ANGLE BRACKET MODIFICATION

Production Change

Effective Serial Number.....1839464

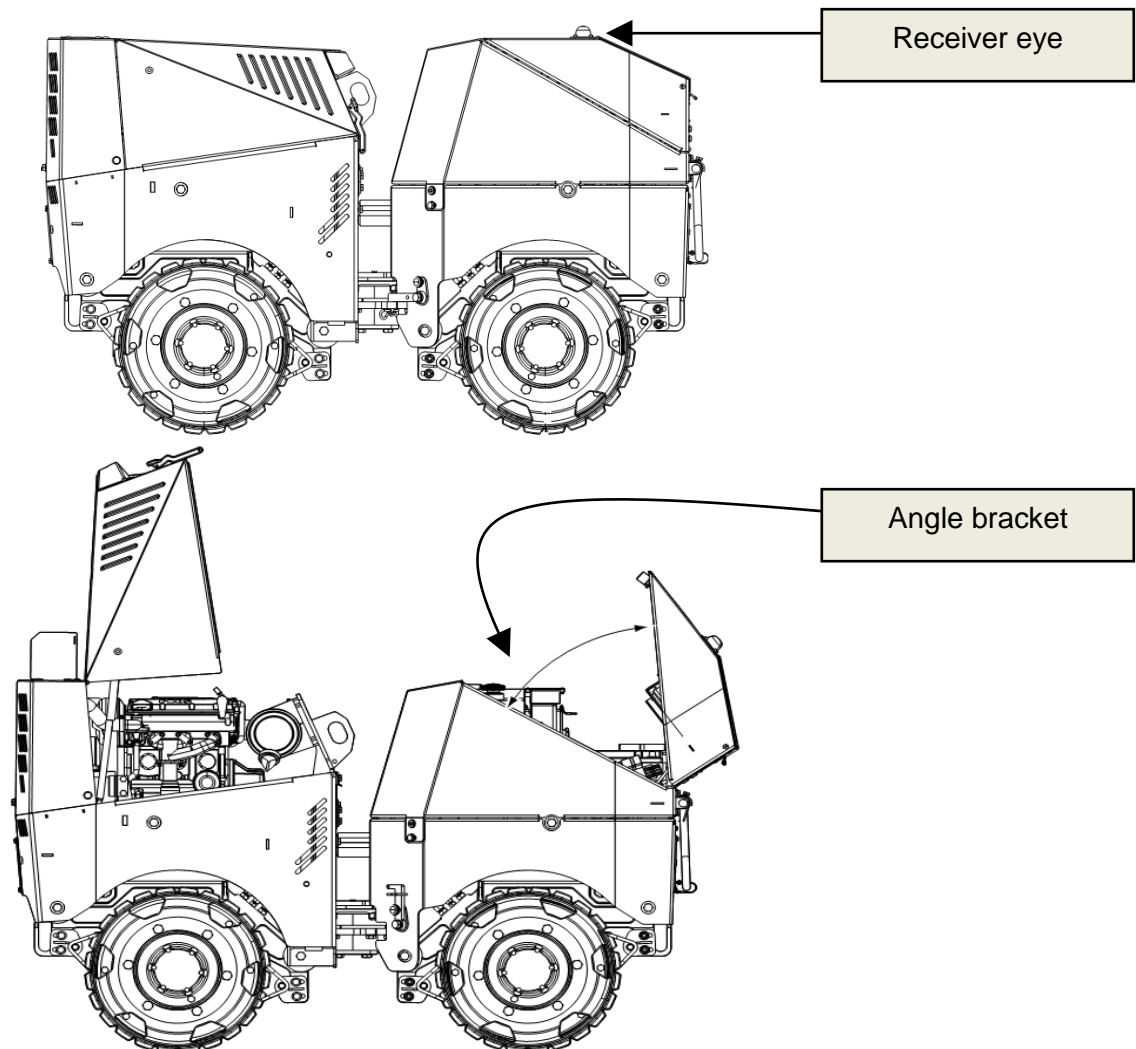
It has been noted as a pre-caution for the angle bracket to be trimmed.

This information is provided as a pre-caution, as this note was taken when a machine became accidentally hit, causing the top cover to shift in result; damaging the receiver eye. Trimming the angle bracket will provide more clearance to the receiver eye.

The receiver eye is mounted to the top cover and is located just above the angle bracket.

TOP VIEW

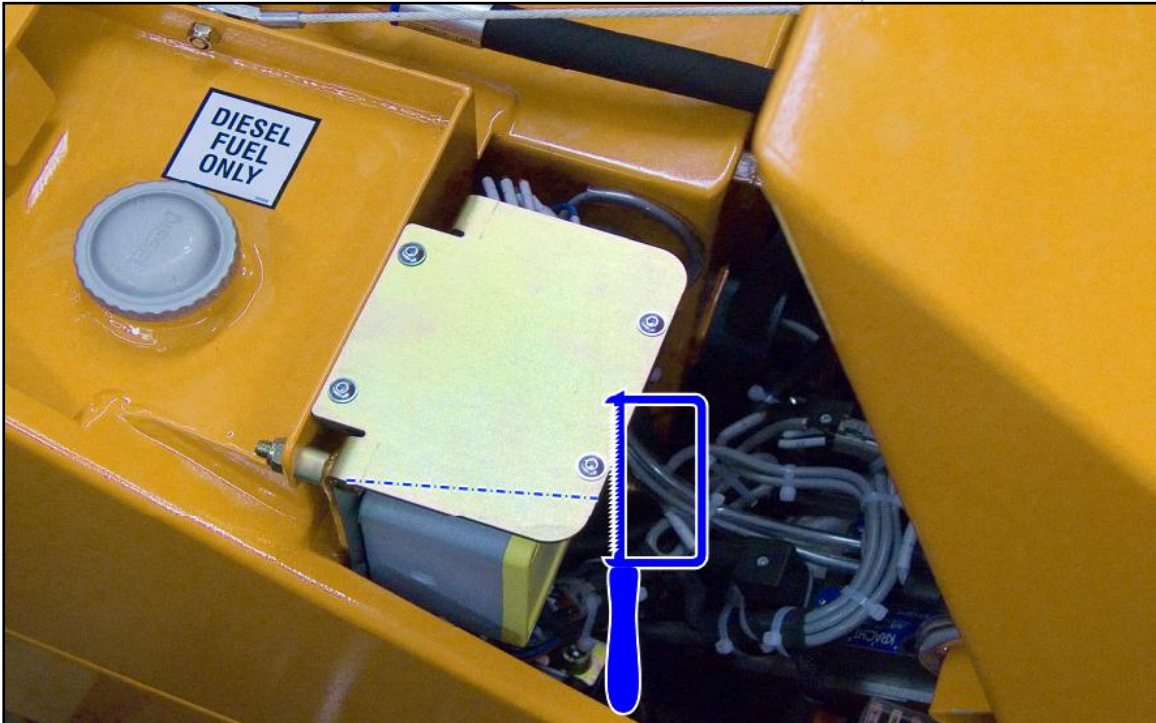
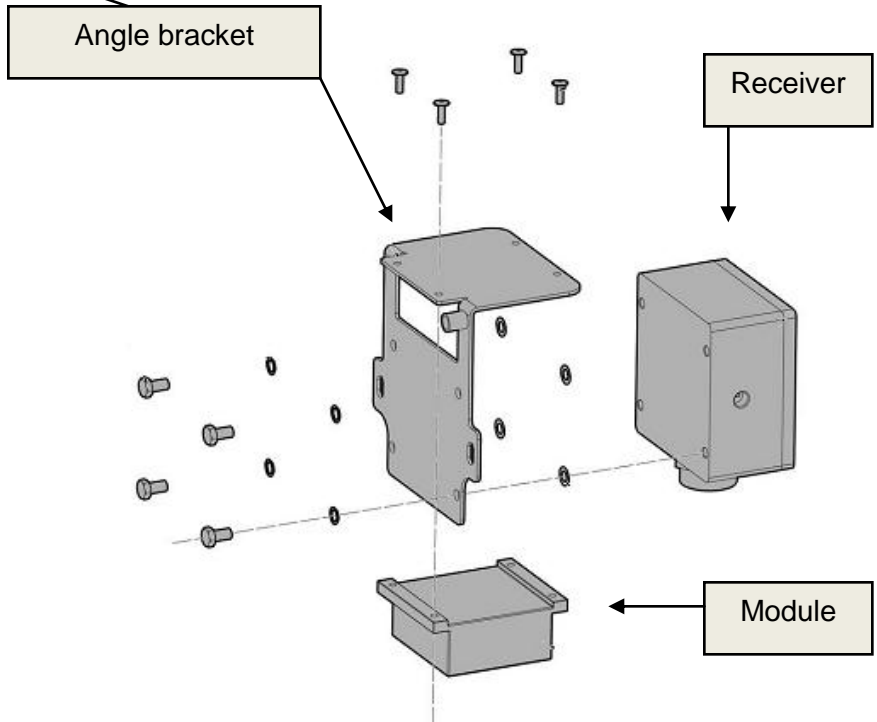
Machines beginning with serial number 1839464 will be manufactured with trimmed angle bracket.

The angle bracket houses the idle control module and remote receiver, in order to trim the angle bracket it will be necessary to remove the idle control module and receiver.
